**Re: FI RESPONSE - Planning application for demolition of the existing derelict dwelling and the construction of a replacement, two-storey, four bedroom detached dwelling (169.97sqm) at Main Street, Newcastle, Co. Dublin.**

Fig 1. Potential Layout of Adjoining Sites.

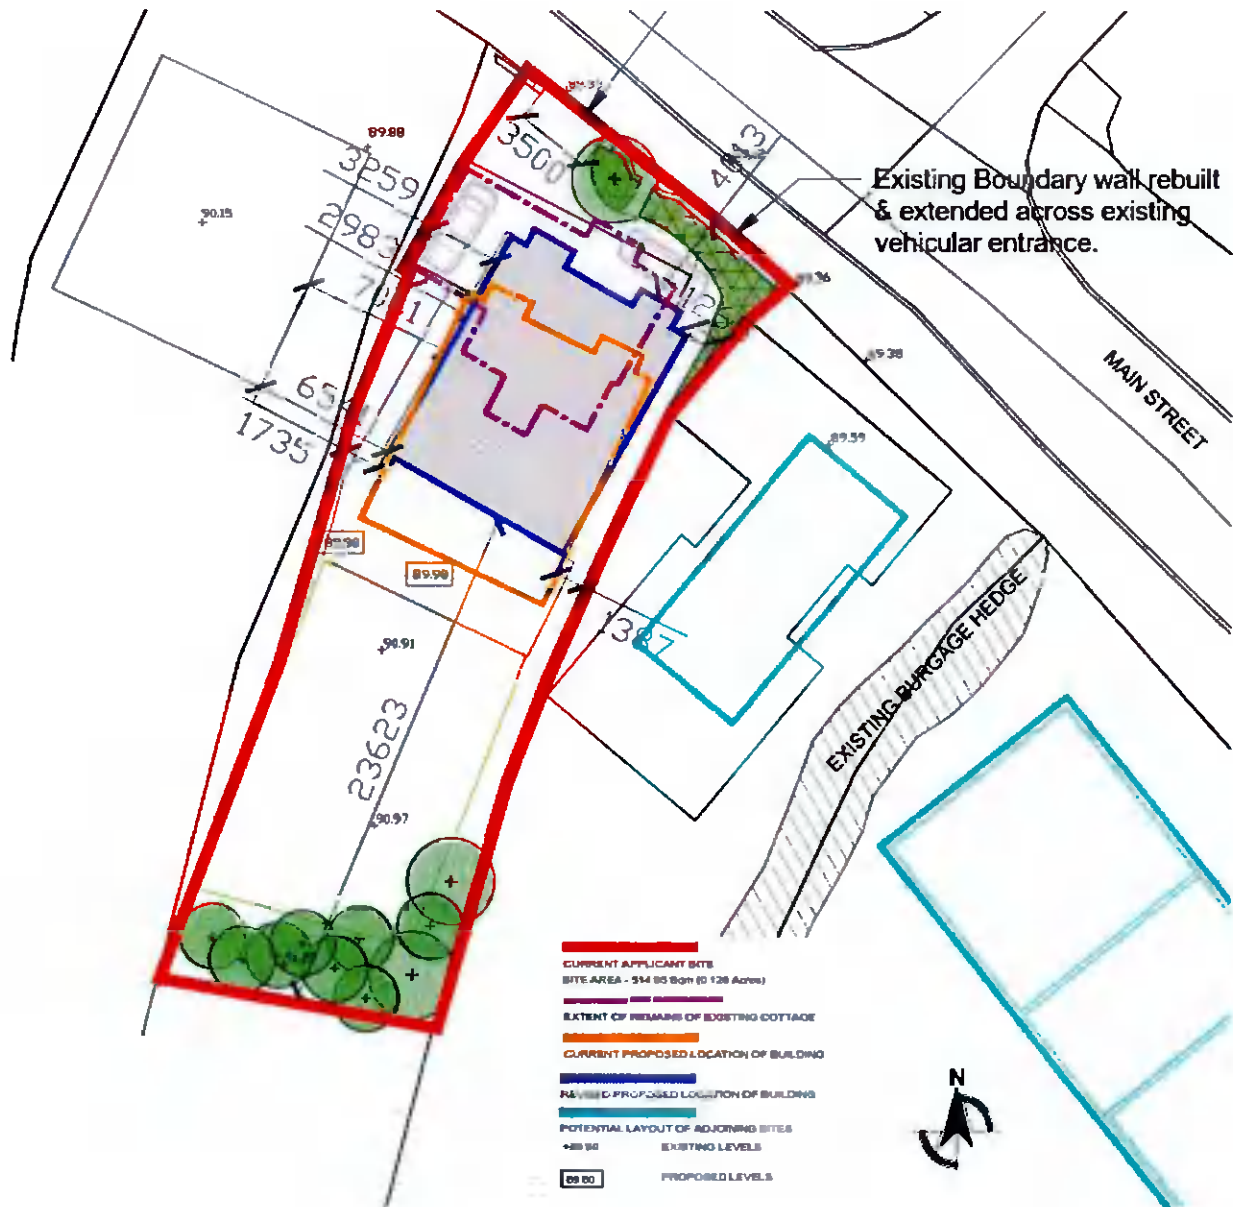
*The applicant is requested to submit revised drawings including a Proposed Site Layout Plan, contiguous elevations demonstrating that the siting and orientation of the proposed dwelling has been altered to create a more uniform building line, in context with adjacent sites, which will contribute to the strengthening of the streetscape along Main Street, Newcastle.*

The position of the proposed dwelling has been brought forward to match the precedent building line set by the new dwelling to the west of the proposed dwelling. Please see enclosed drawing *Proposed Site Layout Plan 01-XXDR-A-PL-01100-P-02* which shows the building brought forward and also indicates the previously proposed location for the dwelling for reference. Also enclosed is Mola Architects drawing *Proposed Plans, Sections and Elevations 00-XX-DR-A-PL-001200-P-02* showing how the proposed dwelling fits with the established scale and style of Main Street.

Furthermore, the sketch below shows how the proposed building line would fit with any future development of the plots to the east of the proposed dwelling.
